Request for Quotation

RFQ NUMBER
 PTR09022

LINE	QUANTITY	UOP	CAT NO.	ITEM NUMBER	UNIT PRICE	AMOUNT
***** ADDENDUM NO. 2 *****						
THIS ADDENDUM IS ISSUED TO PROVIDE THE ATTACHED AGENCY RESPONSES AND CLARIFICATIONS FOR THE REQUESTS FOR APPROVED EQUALS.						
THE BID OPENING REMAINS 03/18/2009 AT 1:30 PM						
0001	1	EA		557-60		
LOW-FLOOR TRANSIT VEHICLE WITH WINDOWS WITH A/C						
***** THIS IS THE END OF RFQ PTR09022 ***** TOTAL: _____

Request for Approved Equals
Addendum #3

ADD OPTION M: Exterior Retro Package: See attached Photos of examples.

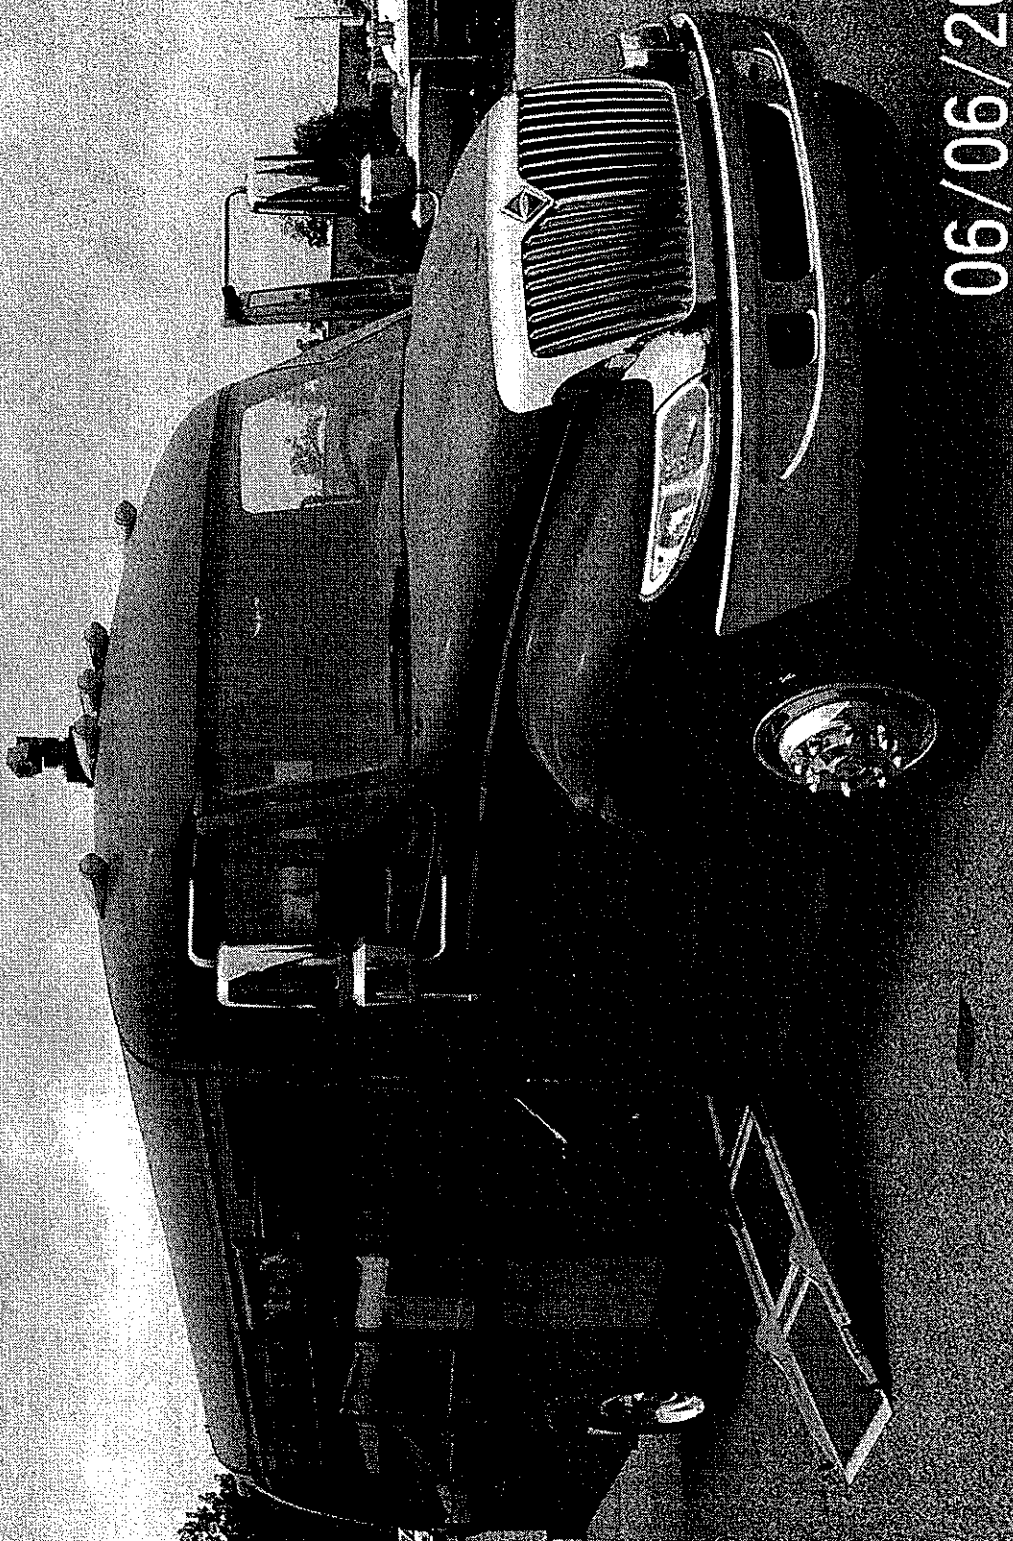
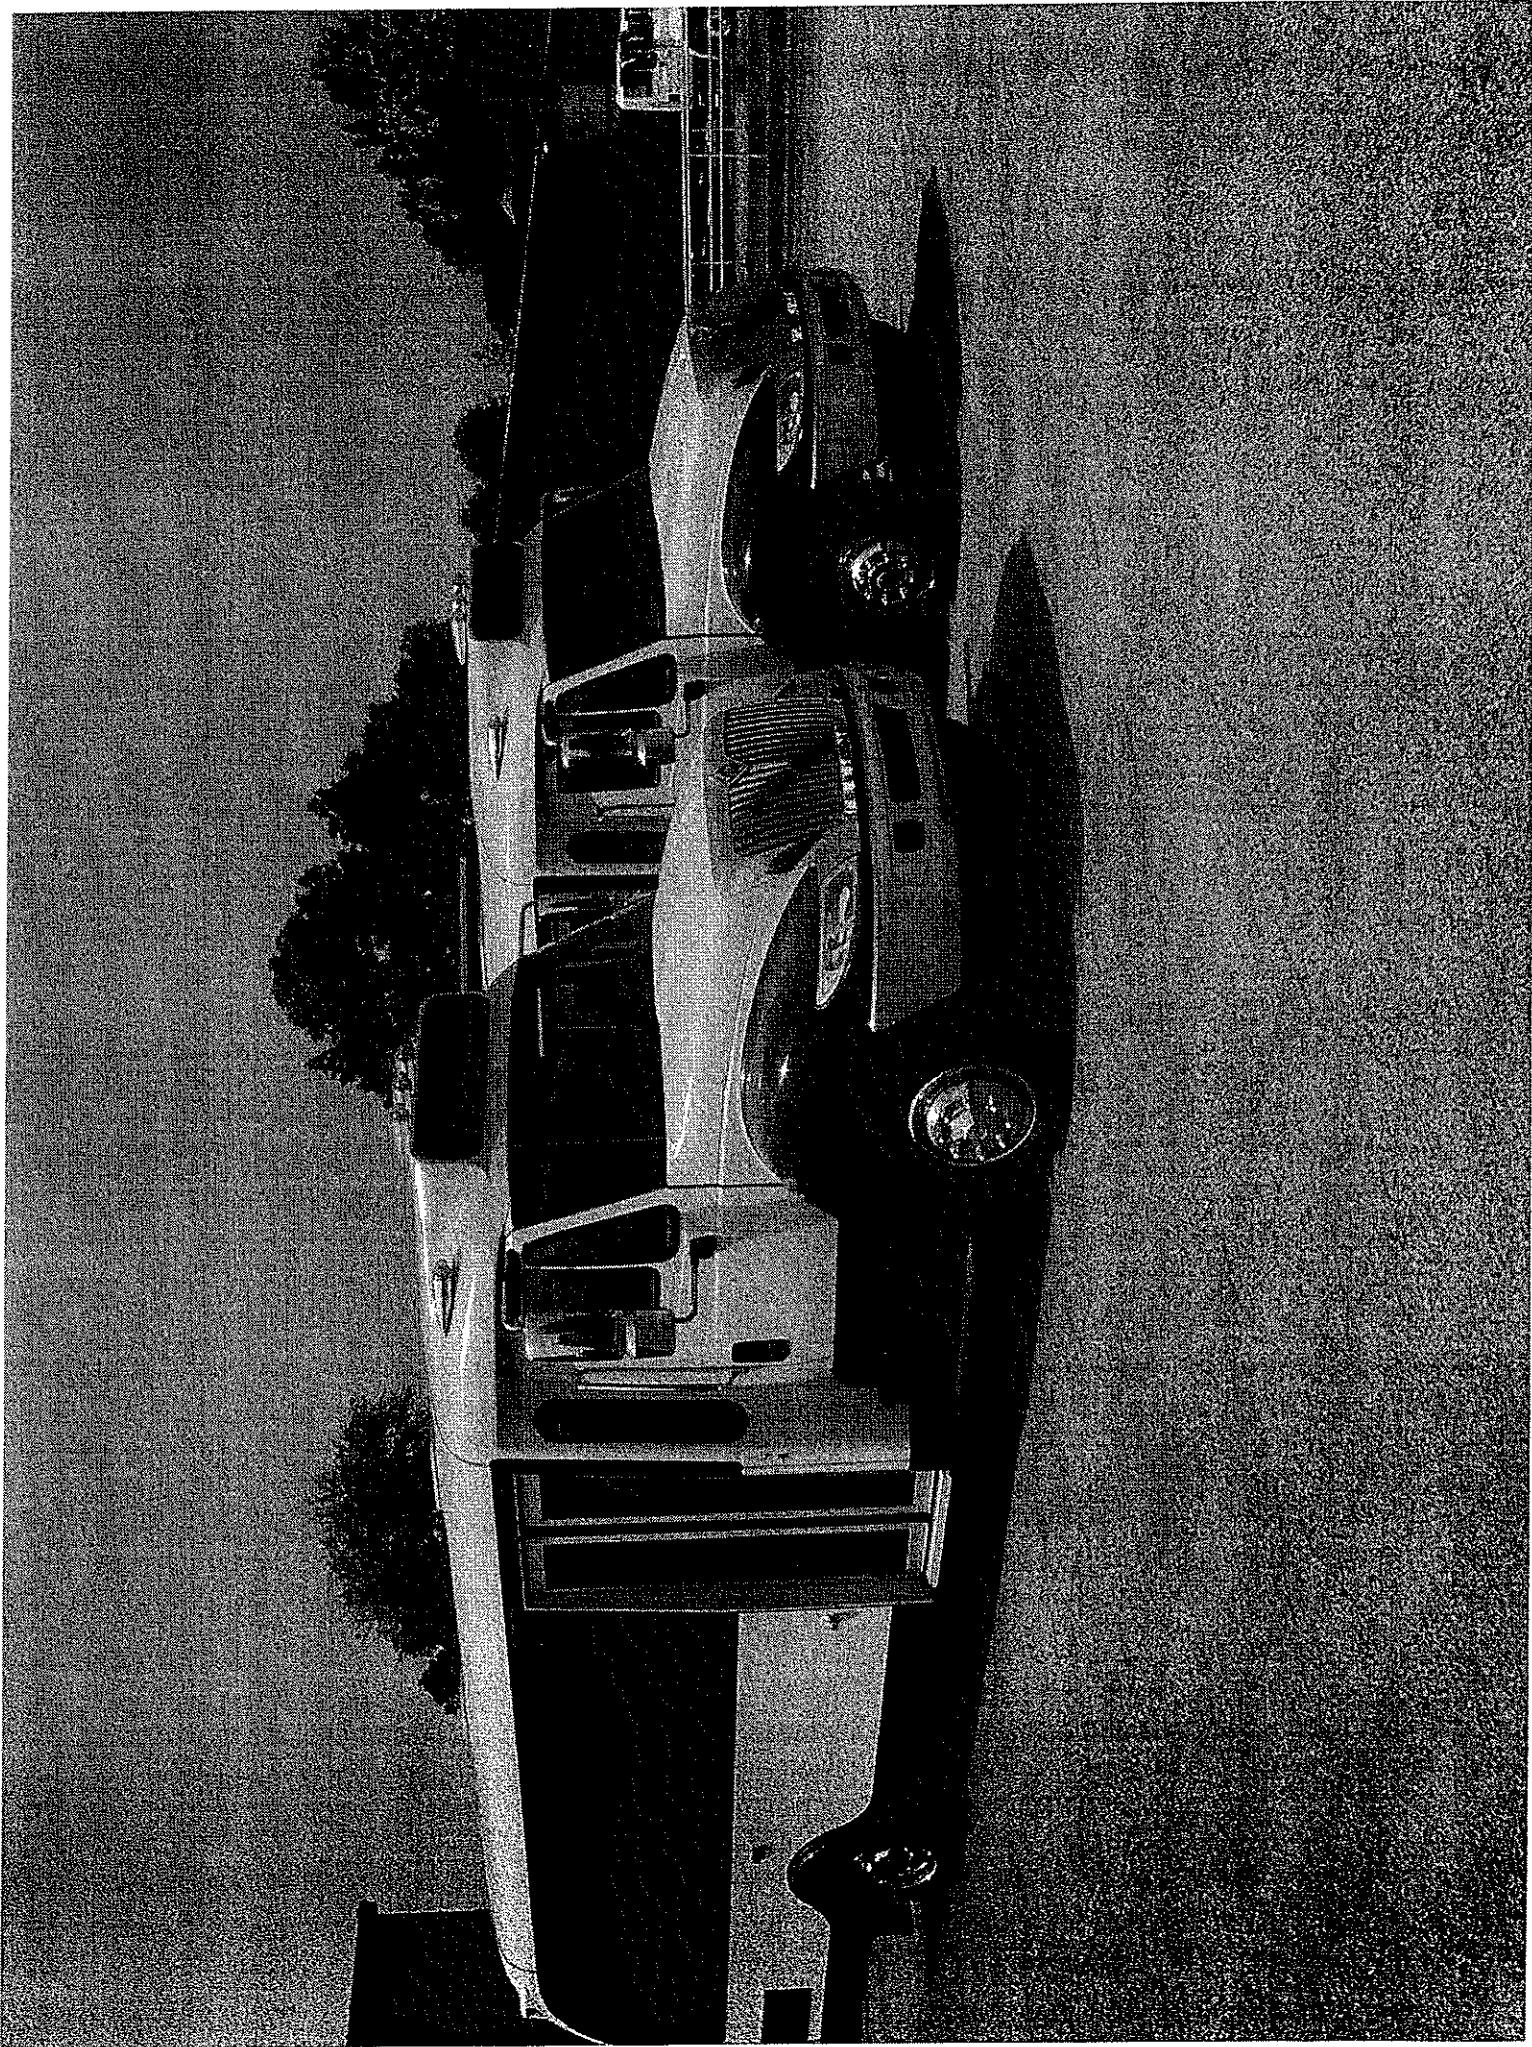
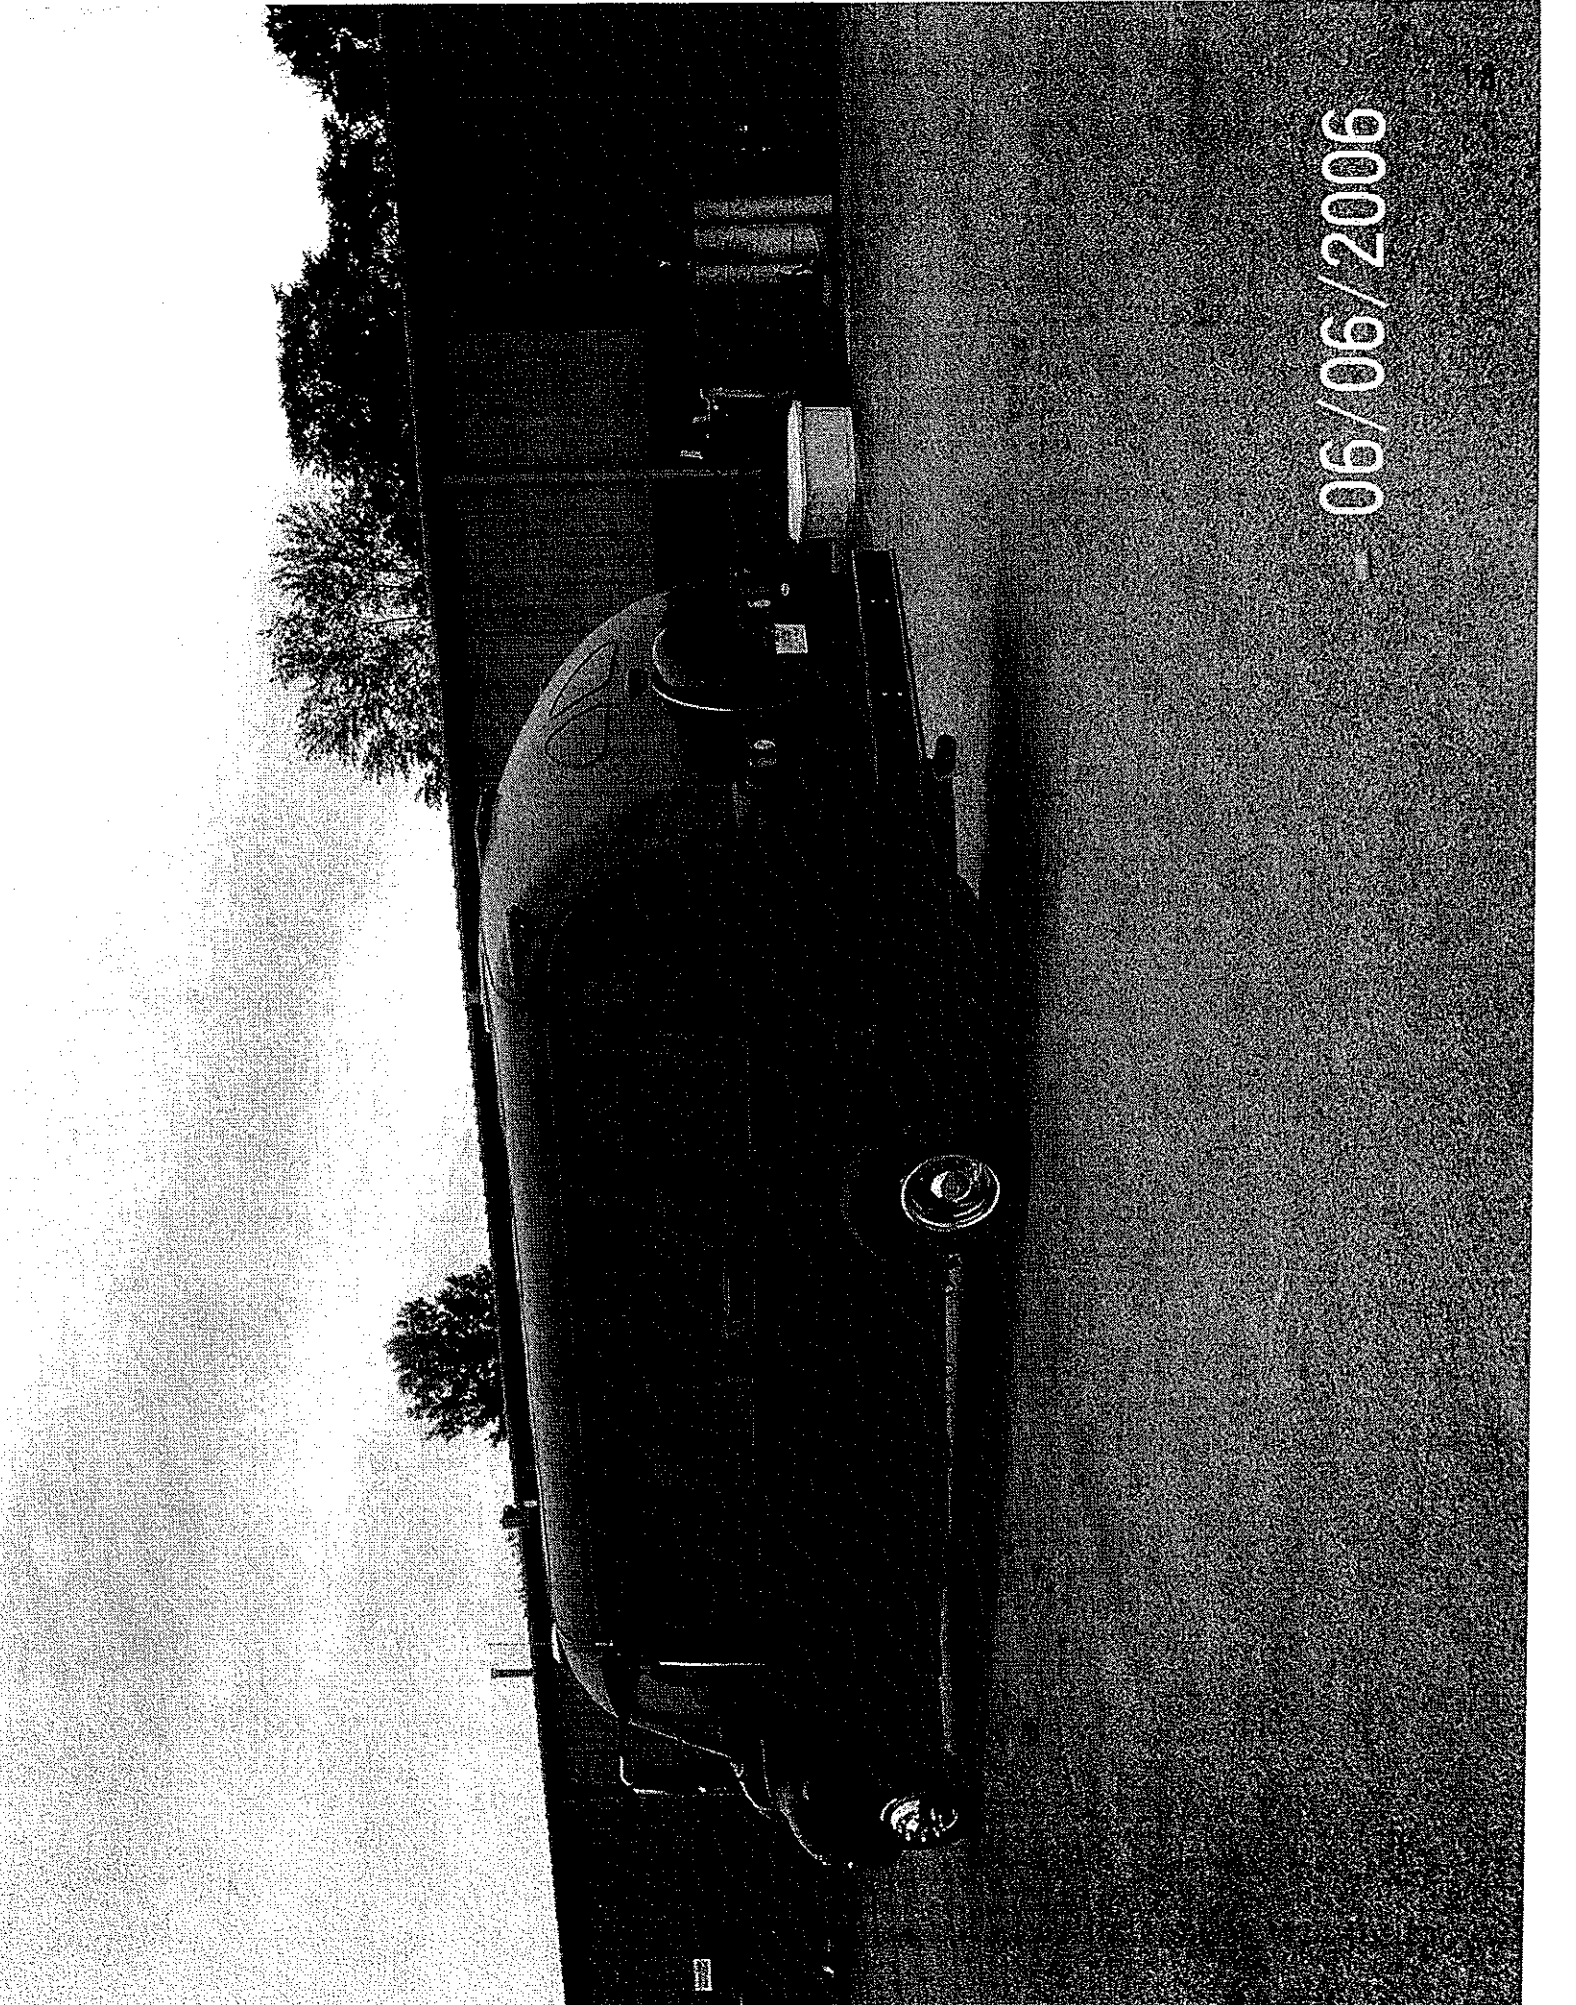
Manufacturer will use a combination of additional body parts, paint and graphics to replicate a 1950 era transit bus. Proposed drawings of the manufacturer's package must be submitted with the bid.
